Service Information

Issued by
Nuffield Exports Limited

INDEX (Sheet 1)

GEARBOX
(Service Modification only)

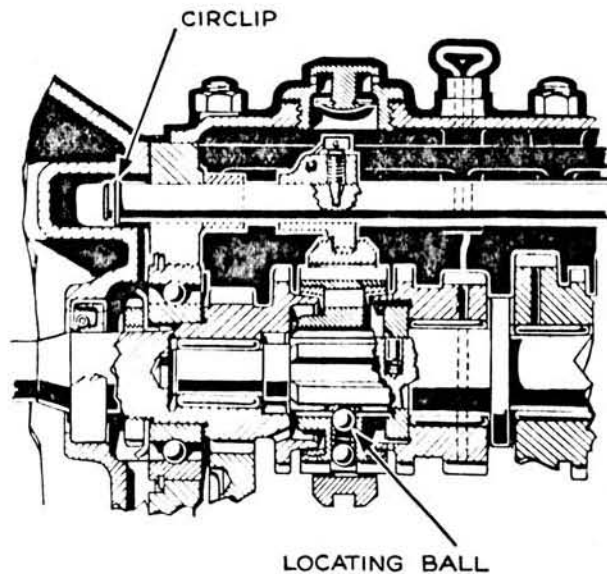
Further to S.I.S. No. 81. Cases have been found of the balls and springs being ejected from the top and third synchro hub due to discrepancies in the position of the third speed shifter shaft stop on the gear change cover. To overcome this (and also the possibility of the third gear being inadvertently moved beyond its position when the gear change extension cover is removed), a new shifter shaft is being fitted with a circlip which gives a positive stop for third gear under all conditions.

To further ensure that the synchro balls and springs do not become released, each ball is now being peened into the synchro hub (each with two square-ended depressions at the end of each ball hole around the hub); also a modified top and third striking dog, which is tapered internally each end, is now fitted to maintain the synchro-hub in the correct position.

This part section of the Gearbox indicates the lengthened third speed shifter shaft and its retaining circlip and the location of the additional locating ball in the synchromesh sliding hub.

GREASE LEAKAGE FROM FRONT HUBS

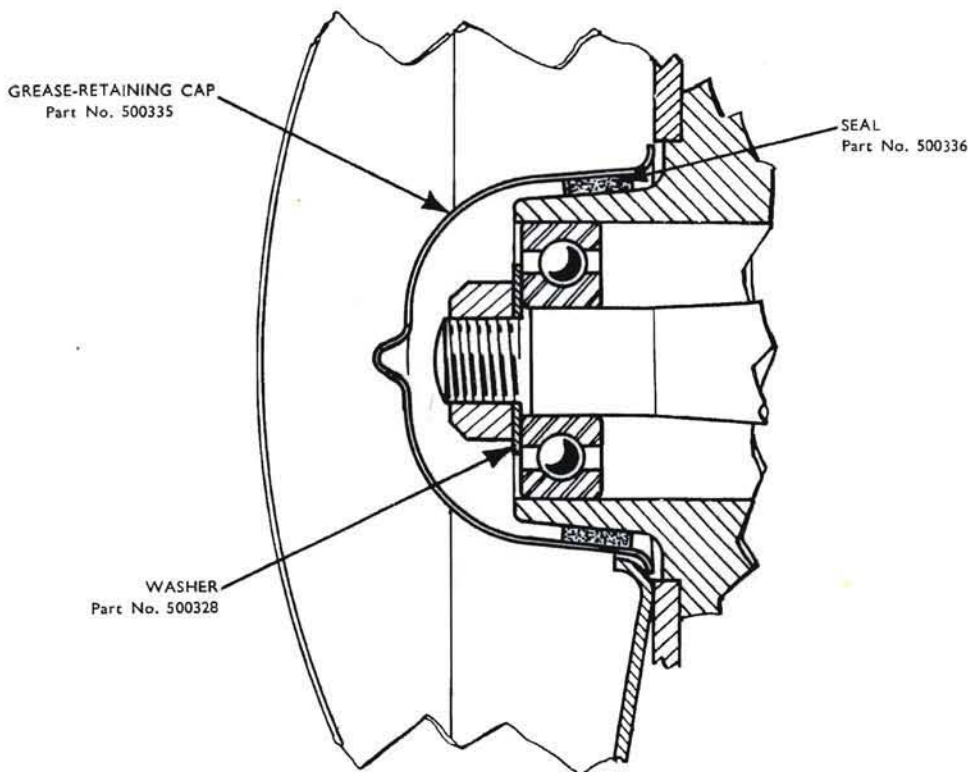
The front hubs have been subject to grease leakage from the outside felt, and a service scheme has been evolved to deal effectively with this, consisting of a grease retaining cap embracing the end of the hub and sealed by an annular felt washer.

This arrangement is clearly shown in the accompanying illustration, and it will be seen that the original oil retaining disc with its felt washer is removed from behind the hub retaining nut and replaced by the flat washer Part No. 500328.

A new oil seal (Part No. 500336) is then fitted over the end of the hub and the new grease retaining cap pushed over this. As the new cap is retained in position by the flanged inner edge of the wheel, it is, of course, necessary to remove the wheel before the cap can be fitted.

Service Information Sheet No. 86**ENGINE DIPSTICK GUIDE TUBES**

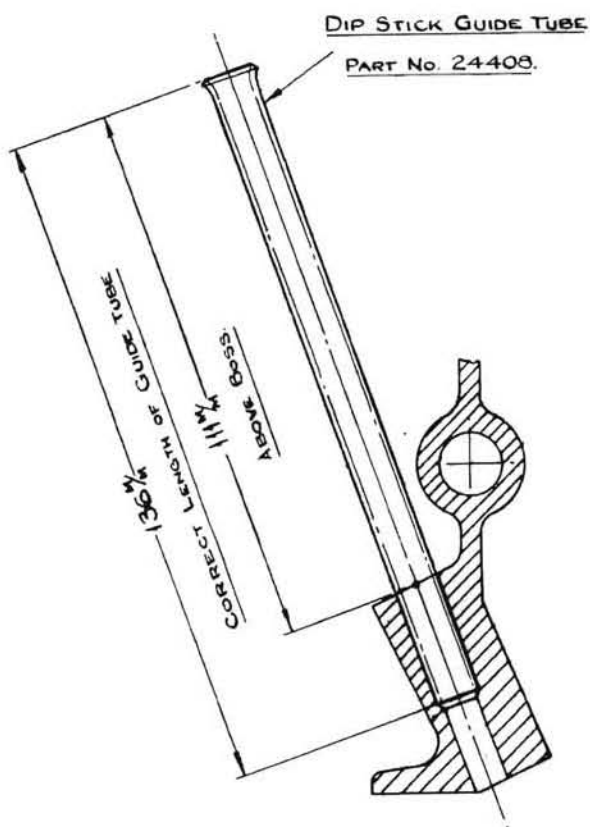
It has been found that on certain M.G. Midget (Series "TD") engines prior to Engine No. XPAG/TD10900, and on M.G. 1 $\frac{1}{4}$ litre (Series "Y") engines previous to Engine No. XPAG/SC17020, an incorrect dipstick guide tube may have been fitted, which is $\frac{1}{2}$ in. longer than the correct guide tube (Part No. 24408). This would, of course, give a false indication of the level and raise the effective oil level $\frac{1}{2}$ in. above the correct position.

In the majority of cases this will cause no harm, particularly if the level is habitually kept below the "Full" mark, but should the sump be filled above the "Full" mark there is the possibility of the crank-throws dipping in the oil and producing excessive lubrication of the cylinders, etc.

The correct length of the dipstick guide is indicated in the illustration and is easily checked.

If it is necessary to shorten the tube or fit a new one it is easily removed from the cylinder block, in which it is a press fit, by twisting it with suitable grips while pulling it out.
